DSO6054L-01-S

Safety Service Note

DSO6054L Oscilloscope, LXI, 4-channel, 500 MHz

The Problem – A Foam Filled EMI Gasket was used in the units listed above. It was implemented in a total of 52 6000L units starting in Nov'2019 with SN: MY5945xxxx in response to a change in EMI qualification. It has been found that the Foam Filled EMI Gasket, if placed incorrectly, may not meet the safety creepage and clearance requirements and could cause a safety risk to the user.

Figure 13 Removing the cover

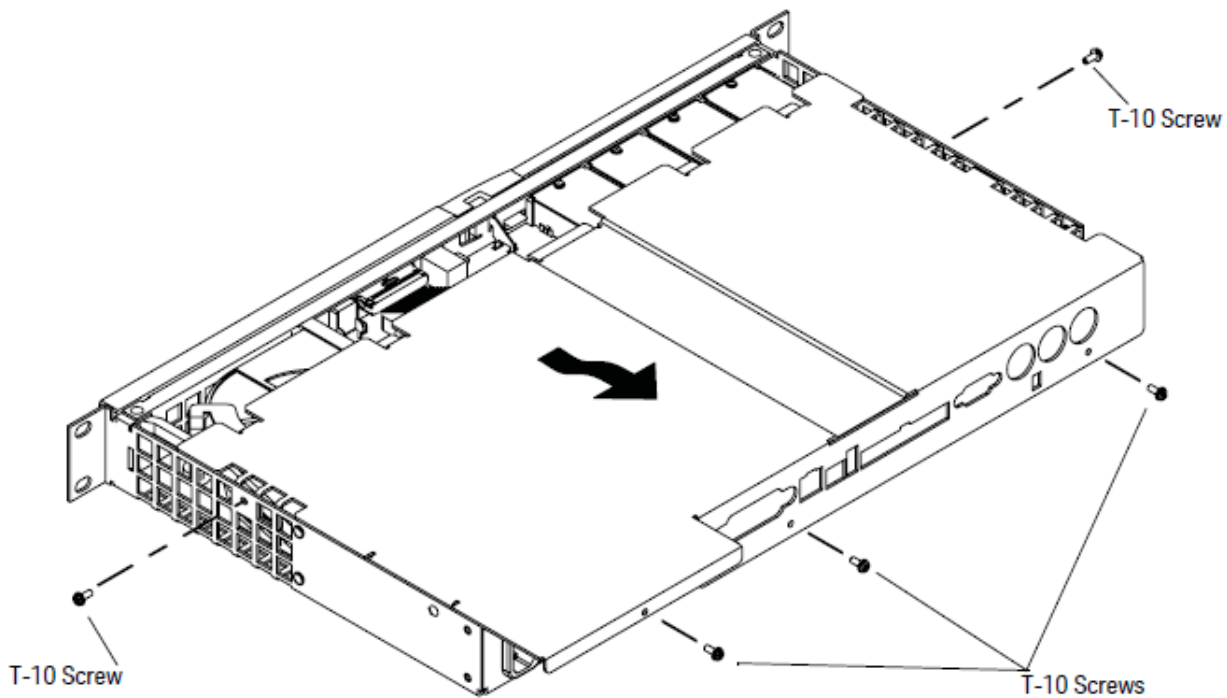
- replace the existing Cover Assembly with a new Cover Assembly without the foam EMI gasket
 - and to apply a new clip-on EMI Gasket Fingerstock (D6104-00104) to the affected units.
1. Remove and scrap the original cover assembly (D6104-00104) with the foam EMI gasket from the scope.
 - Turn off the oscilloscope and disconnect the power cable.
 - Turn the oscilloscope so the bottom is facing up.
 - Using a T10 screwdriver, remove 5 screws from the rear and sides of the cabinet.
 - Slide the bottom cover back and up to remove.

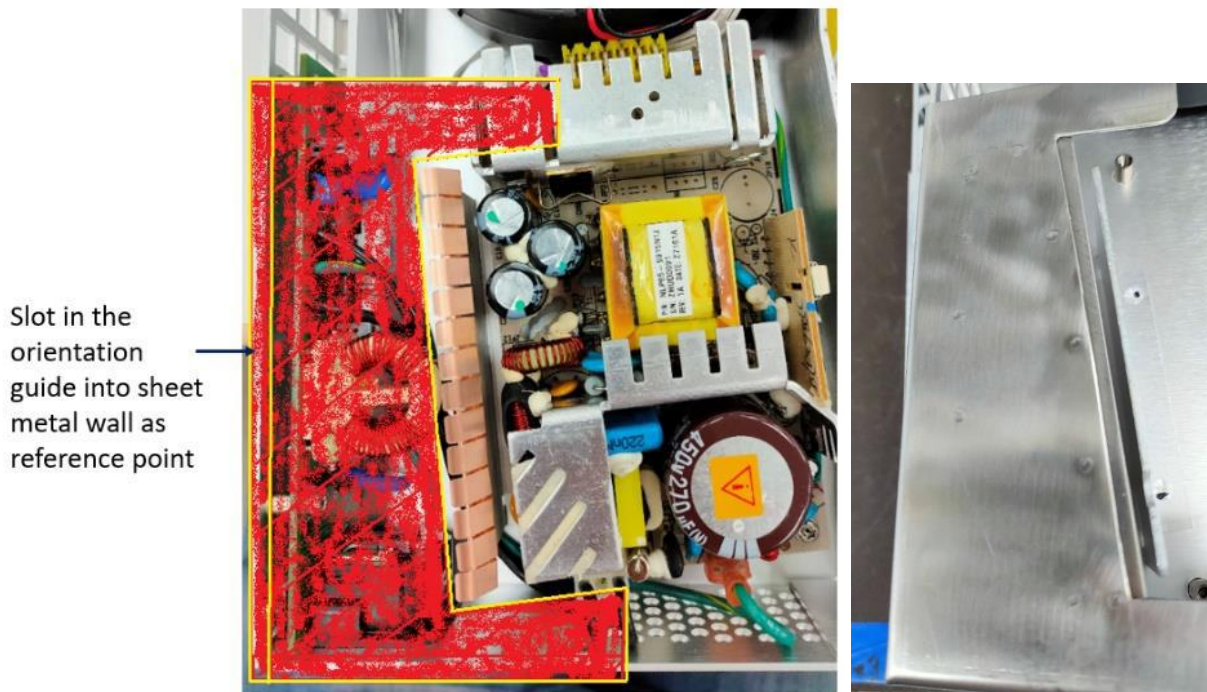
2. Prepare the Gasket Orientation Guide and 1pcs of the new Clip-on EMI Gasket Fingerstock (D6104-85405) as shown below:

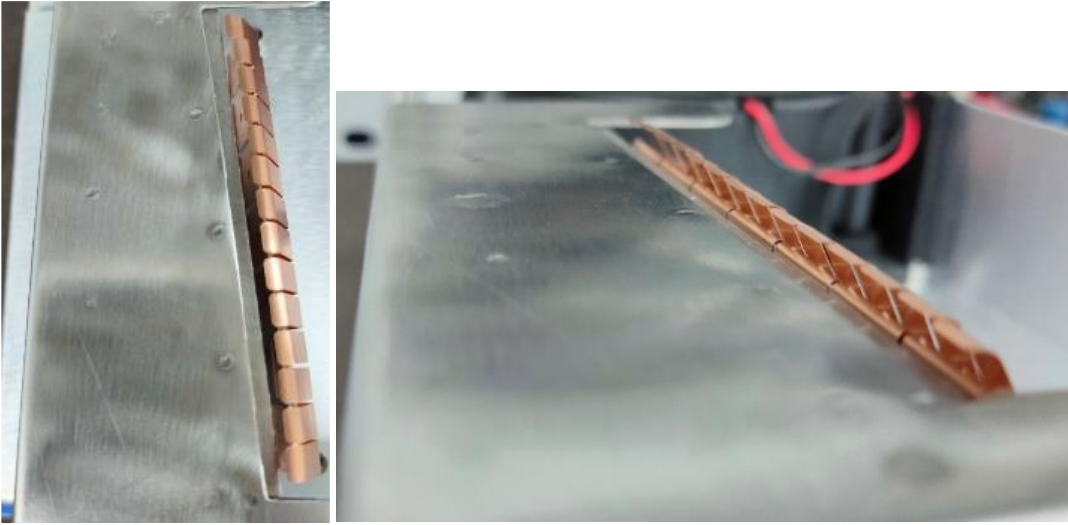
3. Slot in the Gasket Orientation Guide into the chassis as shown in the picture below:

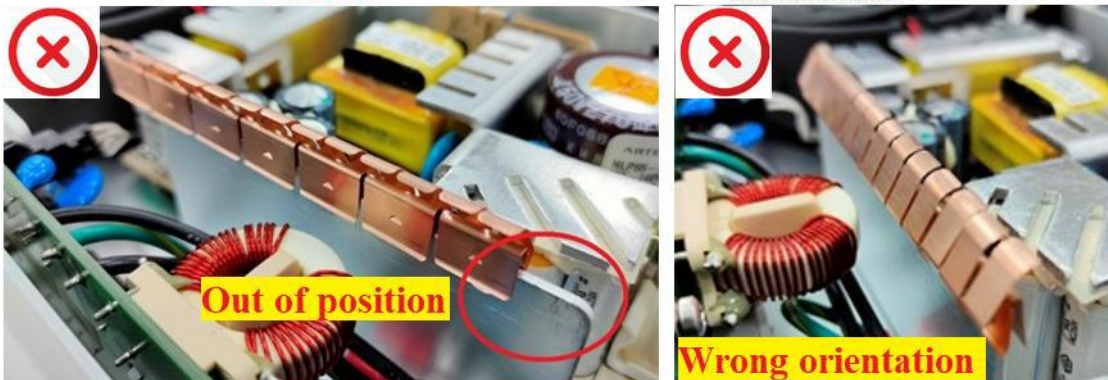
4. Insert the Clip-on EMI Gasket Fingerstock (D6104-85405) into the sheet metal divider and press it with finger force until it is fully inserted as shown in pictures below.

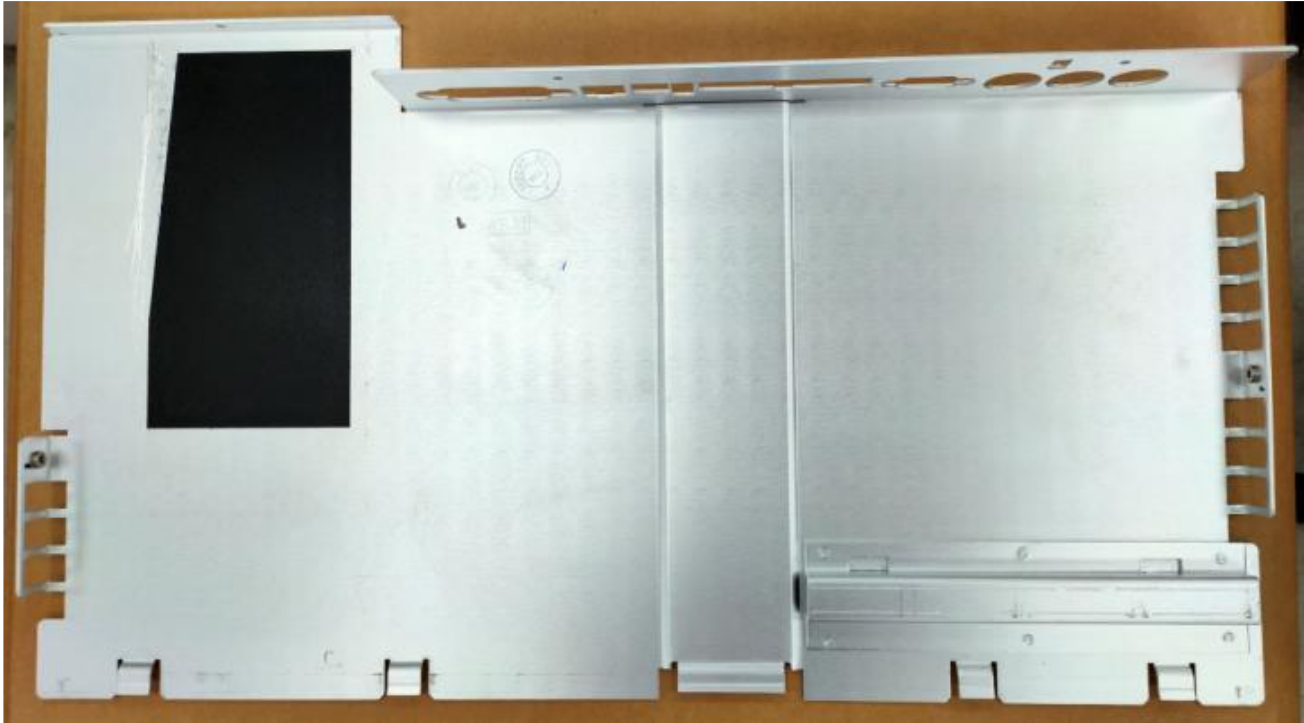
Example of **WRONG** placement of EMI gasket Fingerstock as below:
